RESEARCH REACTOR CENTER

REFERENCE: Docket 50-186
University of Missouri-Columbia Research Reactor
Amended Facility License No. R-103

SUBJECT: Written communication as specified by 10 CFR 50.4(b)(1) regarding responses to the
"University of Missouri at Columbia - Request for Additional Information Regarding
the Renewal of Facility Operating License No. R-103 for the University of Missouri at
Columbia Research Reactor (TAC No. ME1580)," dated June 18, 2015

On June 18, 2015, the NRC requested additional information in the form of two (2) questions.

Figure 1 – Effect of Core Residence Time on ^{10}B Atom Density in MURR Control Blades

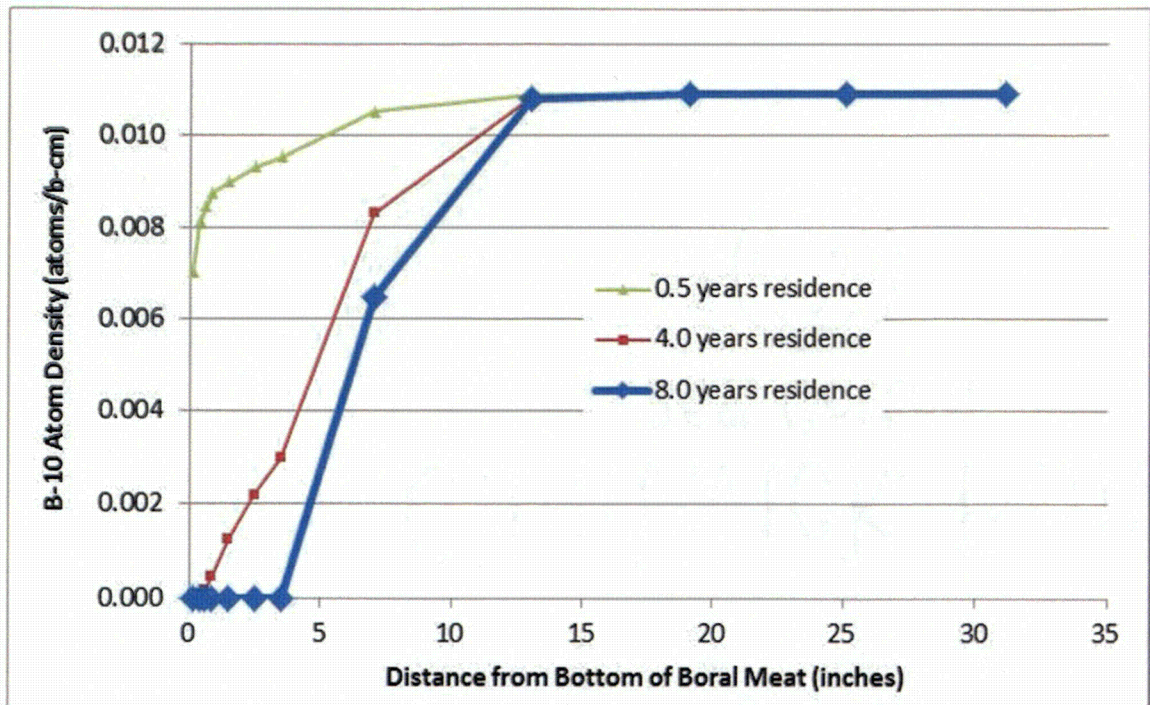
- a. *In Table 3-8, Attachment 10, of your letter dated August 14, 2011 (ADAMS Accession No. ML11237A088), are 15 examples (cases) where critical states were evaluated using the Monte Carlo Neutron Production (MCNP) code. The average deviation provided is approximately 0.64 percent delta k/k (% $\Delta k/k$) (640 percent millirho (pcm)) and the maximum is 1.697 % $\Delta k/k$ (1697 pcm). During discussions with your staff, they were able to demonstrate better agreement using other models and stated that it is possible that the referenced MCNP calculations were performed with control blades not fully represented. Describe the reasons for the differences between the measured and calculated critical eigenvalues for the 15 cited examples (cases).*

Subsequently, MURR performed a detailed control blade modeling and depletion study using MONTEBURNS. MONTEBURNS, which is a coupled MCNP-ORIGEN program, is the primary tool used for fuel and control blade depletion calculations as well as for various other steady-state neutronic calculations at MURR. The results from the control blade depletion study are summarized in Figure 1 below. It shows the axial distribution of ^{10}B in the control blade meat for blades with different operating histories. The results show that towards the control blade end-of-life (EOL), the bottom four (4) inches of the blade has been mostly depleted of any poison material.

After incorporating the control blade depletion model to the MURR-MCNP model, a series of criticality calculations were performed and the results were compared against the case with non-depleted (fresh) control blades. Table 1 below shows the deviation in $\% \Delta k/k$ from critical state for the two cases. When all-fresh control blades were used in the MCNP simulation (the column labeled “No CB Burnup”), cores with control blades that had the greatest total burnup had the greatest deviation from critical at measured critical control blade heights. However, when the control blades are modeled with control blade depletion compositions (the column labeled “With CB Burnup”), the deviation from critical is much smaller – a reduction from 1.735% to 0.422% for the case with the maximum control blade operating history.

MURR EXHAUST VENTILATION LOADS

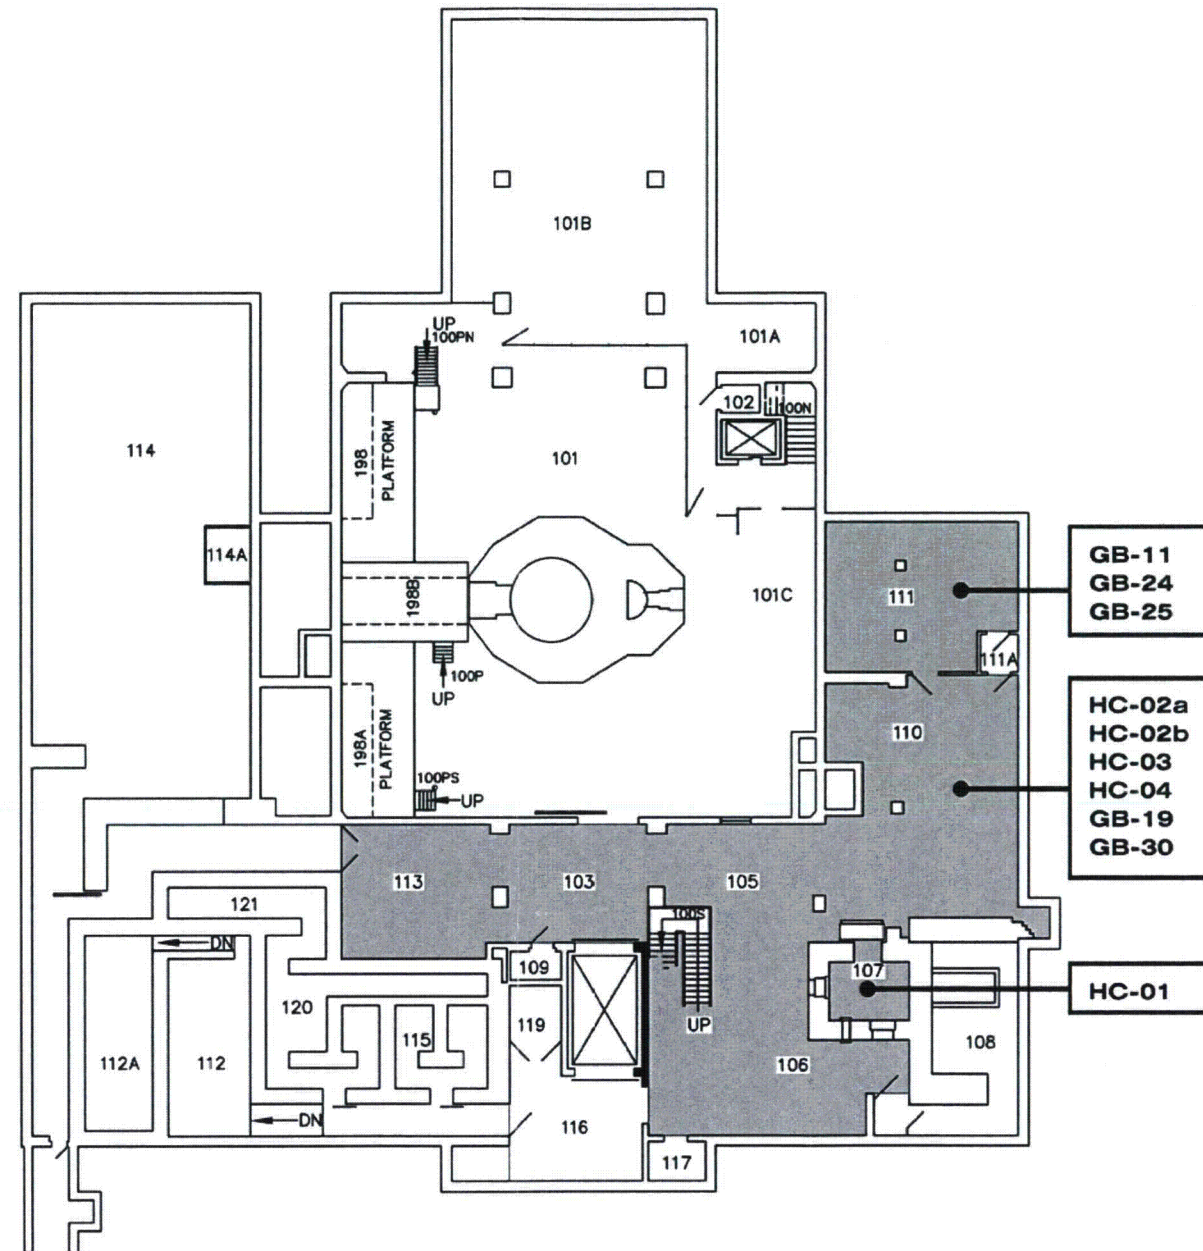
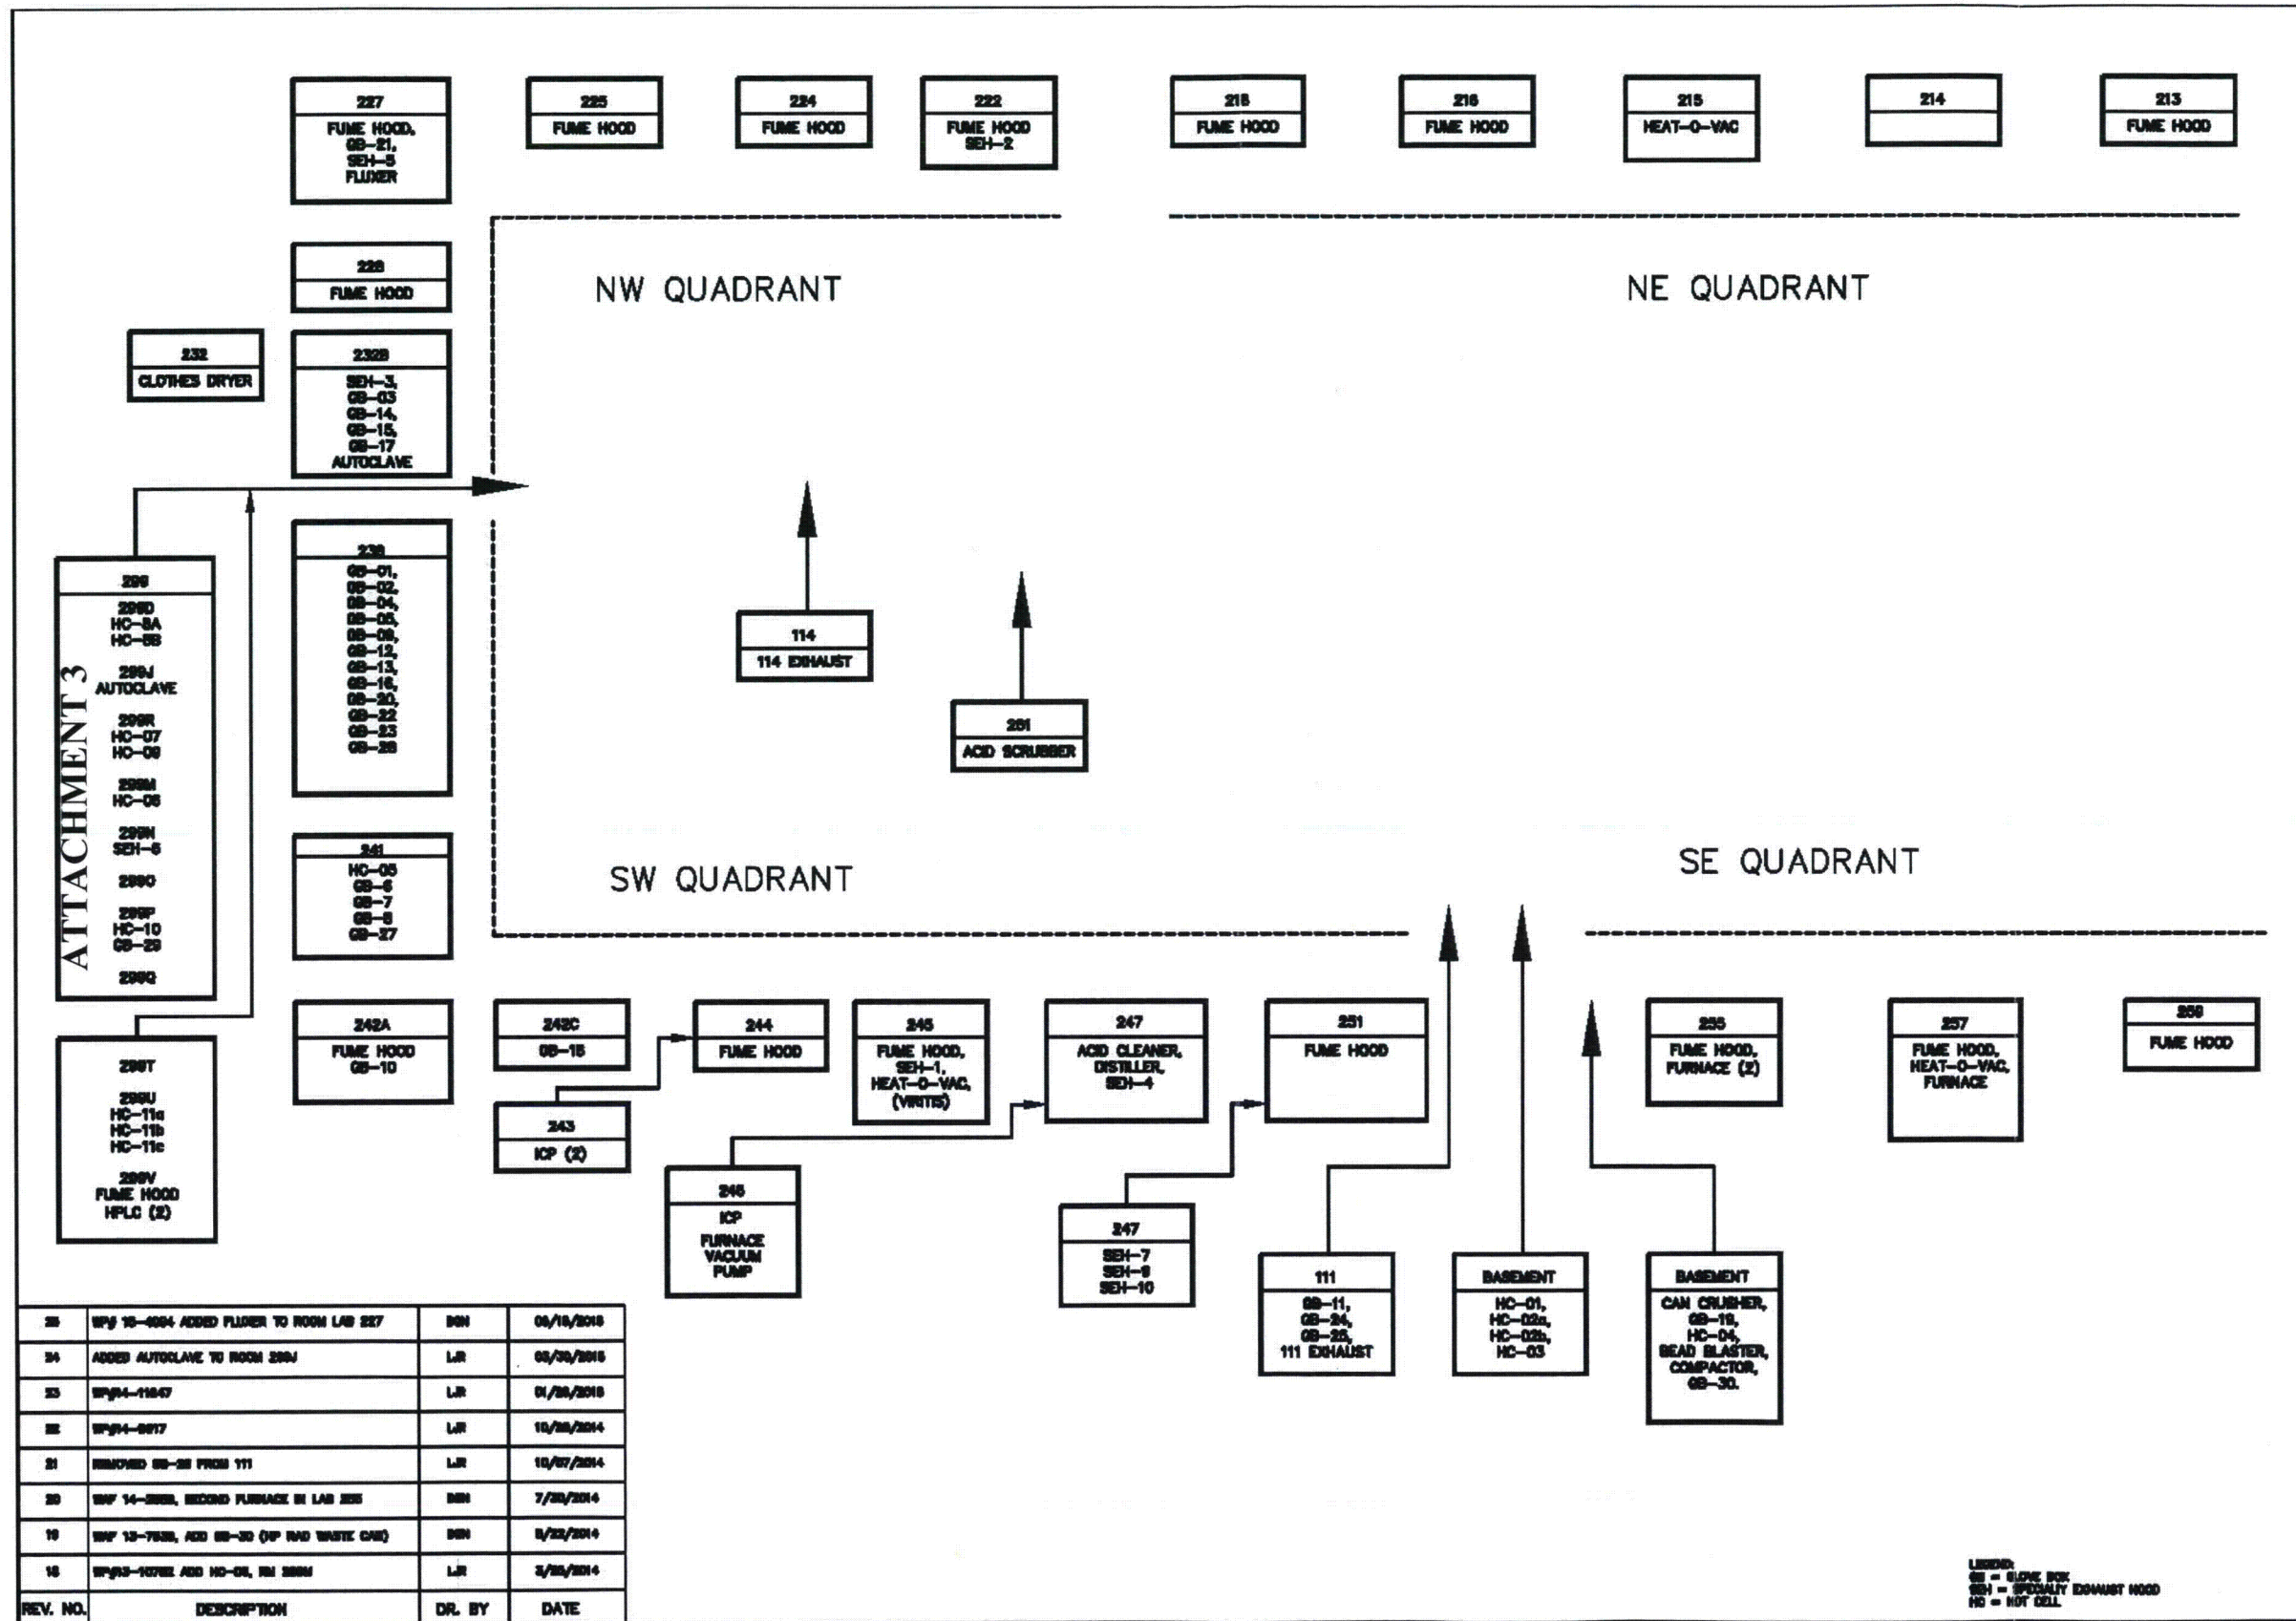
- a. *Provide a comprehensive list of hot cells, glove boxes, and fume hoods under the reactor license. Describe their locations (including a map if necessary), and indicate the appropriate radiological control area boundaries.*

Attachments 1 and 2 provide the locations of all of the hot cells, glove boxes and fume hoods at MURR. Attachment 3 lists all of the loads that are attached to the MURR ventilation exhaust system. The radiological control area boundary for each hot cell, glove box and fume hood is the area that is posted with radiological control signs. Typically that posting is on the room that the hot cell, glove box or fume hood is located in; therefore, the radiologically controlled area is the room itself. Table 1 below lists all of the hot cells, glove boxes and fume hoods in the facility by location, component designation and the typical isotope that is handled within the unit. A large number of the hot cells, glove boxes and fume hoods are for general use, meaning that different isotopes may be handled within the unit but the safety analysis specific to that isotope applies
